**U.S. DEPARTMENT OF ENERGY (DOE) TOPICAL REPORT ON DISPOSAL CRITICALITY
ANALYSIS METHODOLOGY, REVISION 01**

Enclosure 1 is DOE's *Disposal Criticality Analysis Methodology Topical Report*, YMP-TR-004Q, Revision 01, for review by the U.S. Nuclear Regulatory Commission (NRC). Revision 01 of the Topical Report is a continuation of the Topical Report/Safety Evaluation Report process on disposal criticality, and responds to the NRC Safety Evaluation Report (SER), Reference 1, on Revision 0 of the Topical Report.

YMP/TR-004Q

Figure 3-1. Overview of Disposal Criticality Analysis Methodology

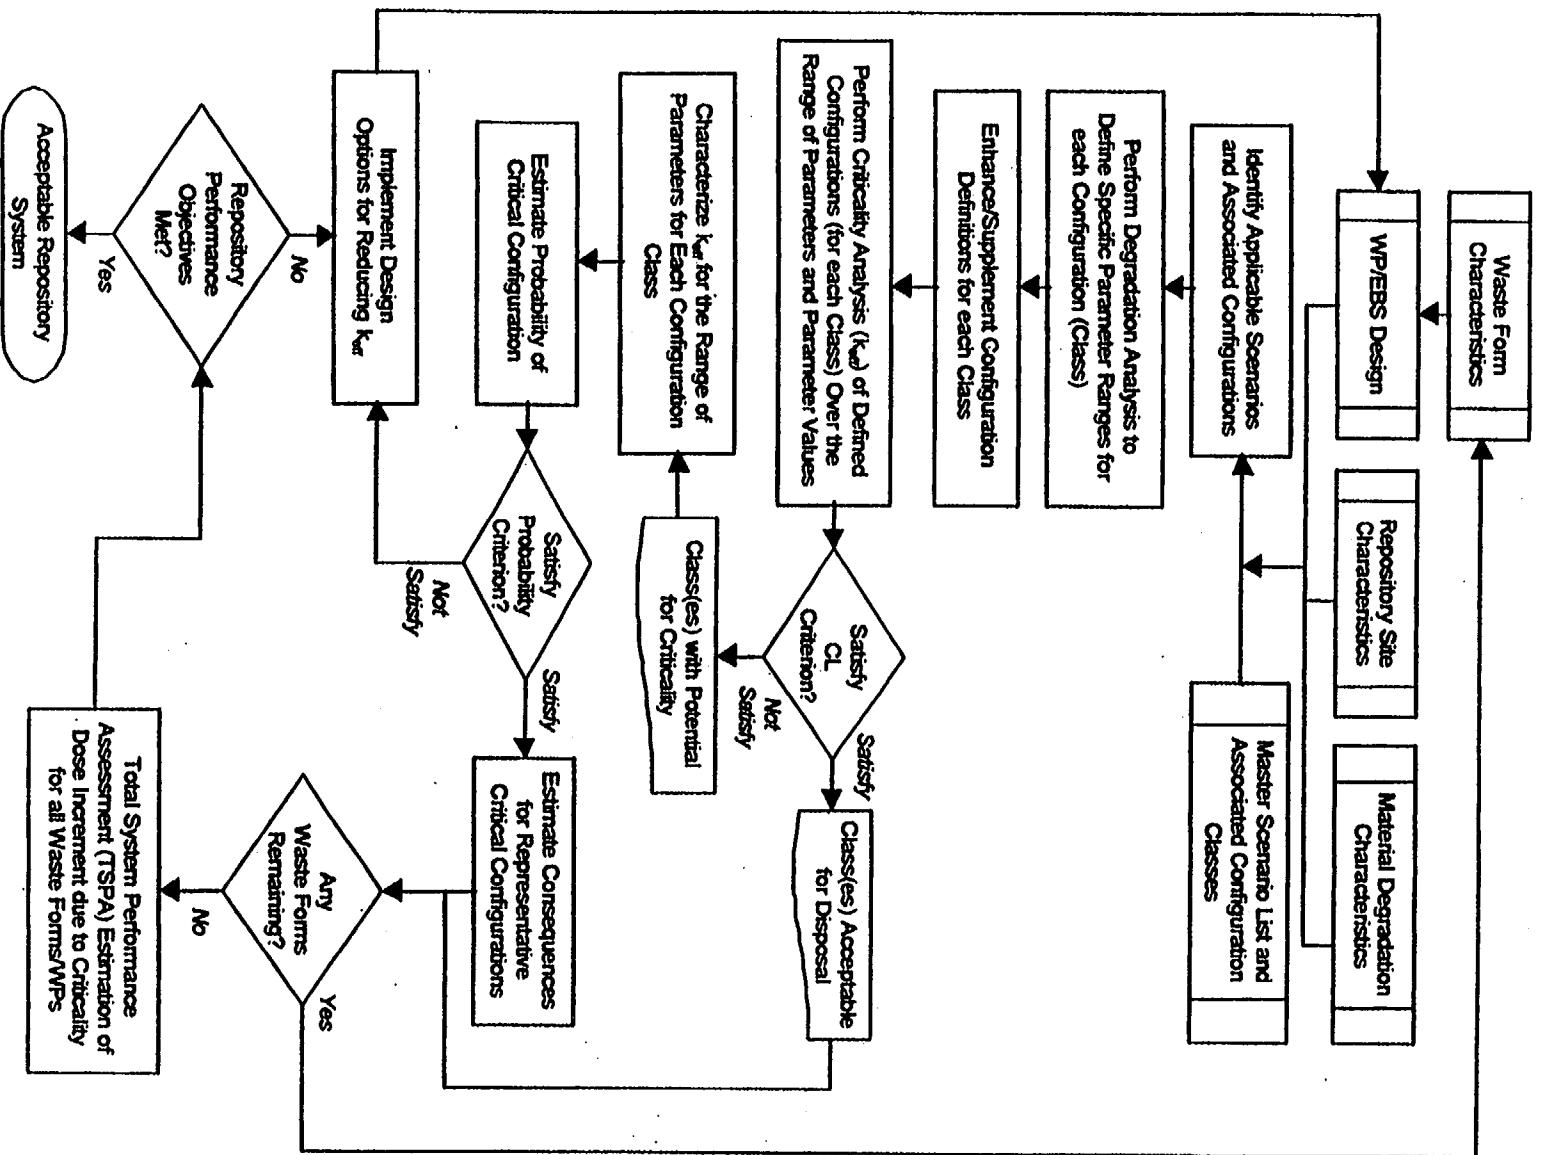
| RAI Action Items | Location in Topical Report Revision 01 |
|--|---|
| 1-8 The box in Figure 1-1 discussed in this RAI will be modified to read: “Perform Criticality Analysis (k_{eff}) of Defined Configurations (for each Class) Over the Range of Parameters and Parameter Values.” | The changes specified were made to Figure 3-1 (Note: Section 1.5 OVERVIEW OF METHODOLOGY was moved to Section 3.1 in Rev. 1 of the Topical Report– thus, Figure 1-1 from Rev. 0 becomes Figure 3-1 in Rev. 1) |

Figure 3-5. Criticality Analysis Methodology

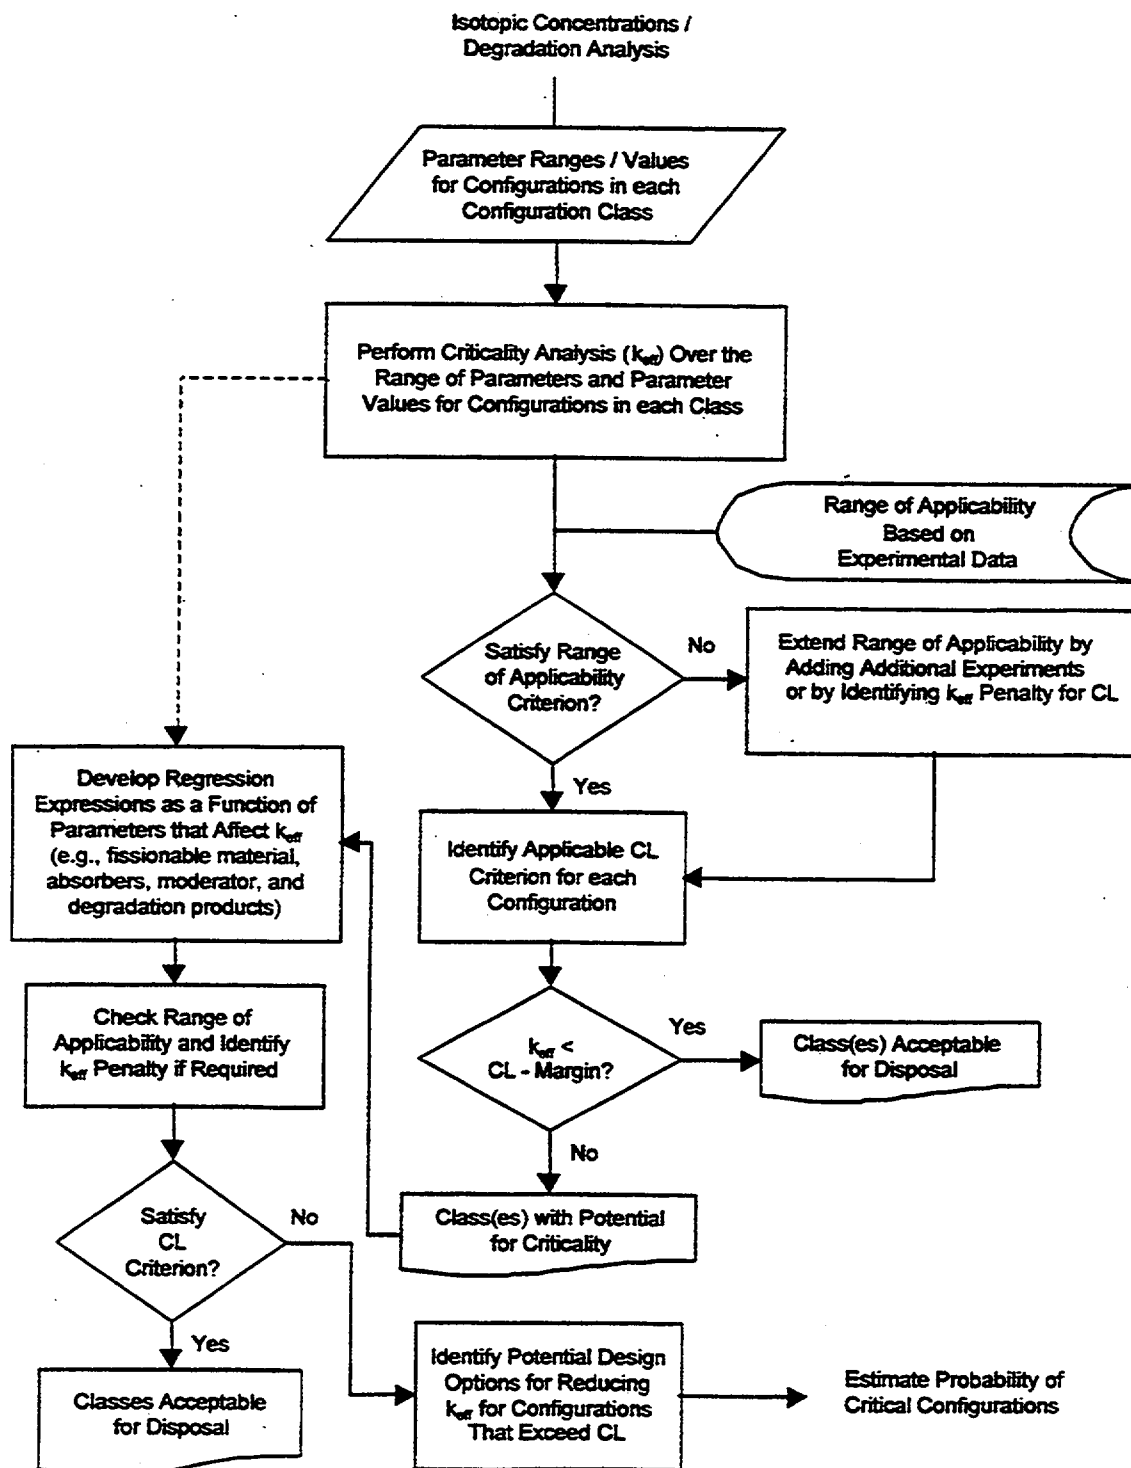
| Open Item | Location in Topical Report Revision 01 |
|---|--|
| #5. The DOE must include a criticality margin when comparing k_{eff} values from regression analyses to CL values. | Section 2.3.2 (8 th paragraph) pp. 2-8 & 2-9 and Figure 3-5 in Section 3.5.1.3 |

Figure 3-8. Process for Calculating Critical Limits

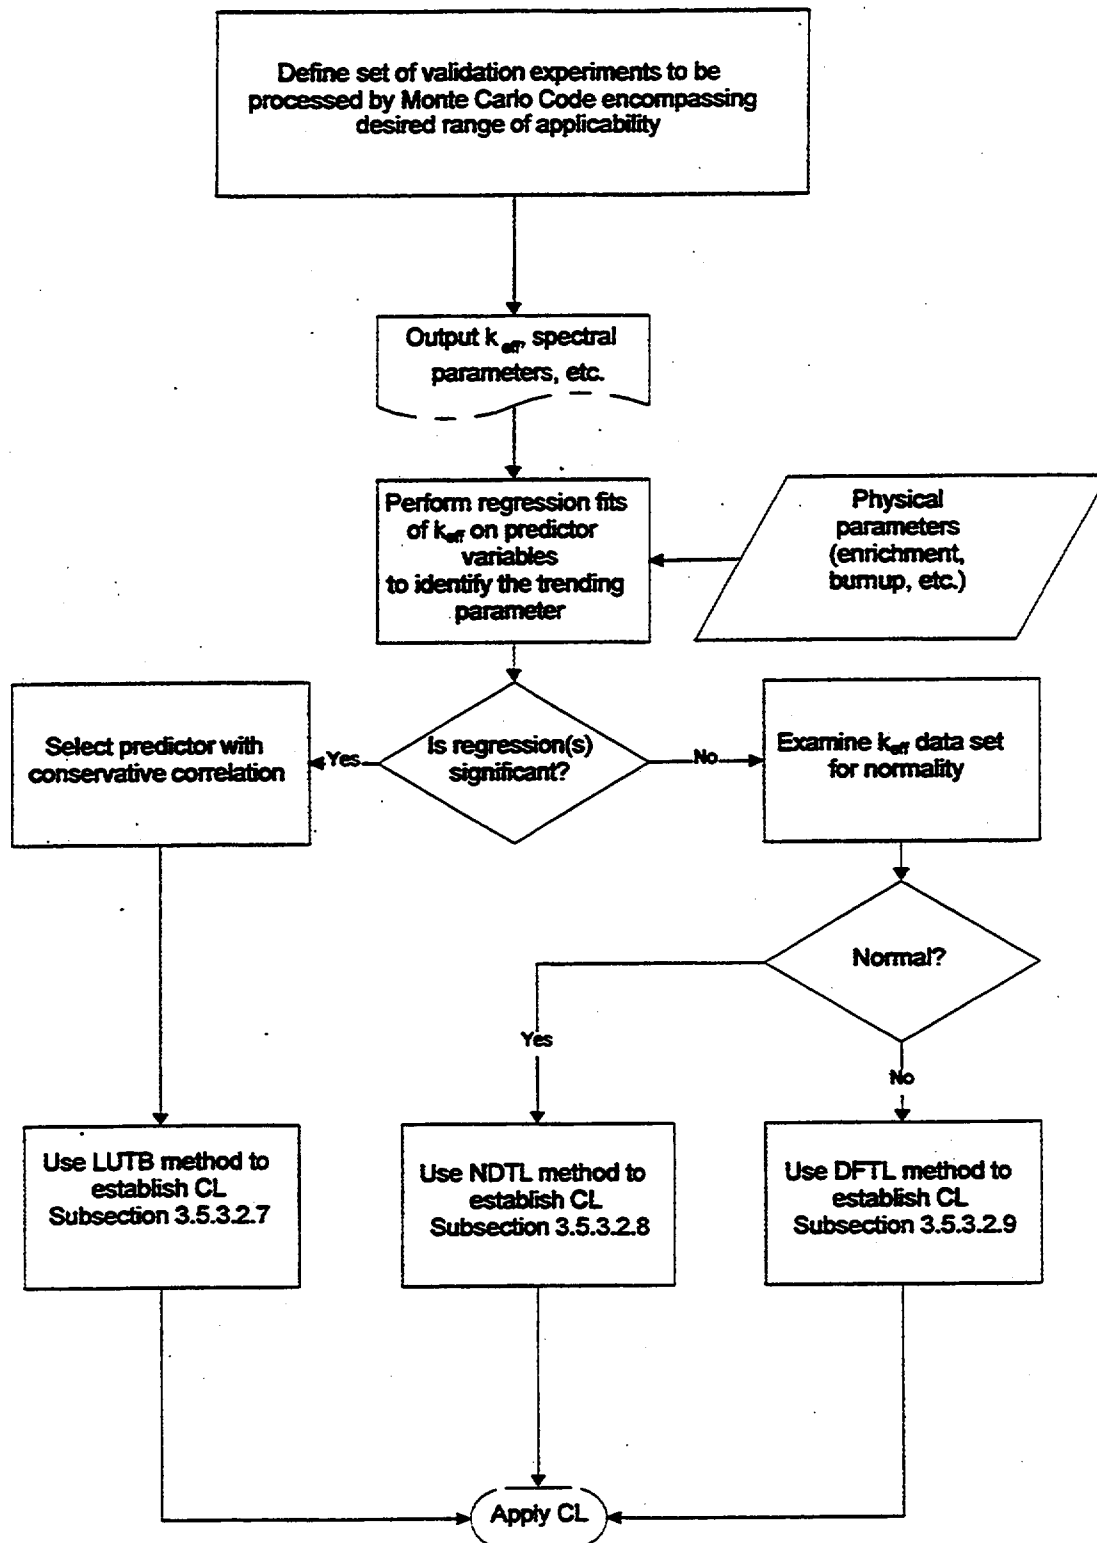
| RAI Action Items | Location in Topical Report Revision 01 |
|--|--|
| 4-7 None - Clarification and additional discussion was provided relative to incorporating information specified in the RAI into Figure 4-1 of Rev. 0 of the Topical Report (Figure 3-8 of Rev. 1). Additional discussion is provided in Subsection 3.5.3.2.6 of Rev. 1 of the Topical Report. | NA |
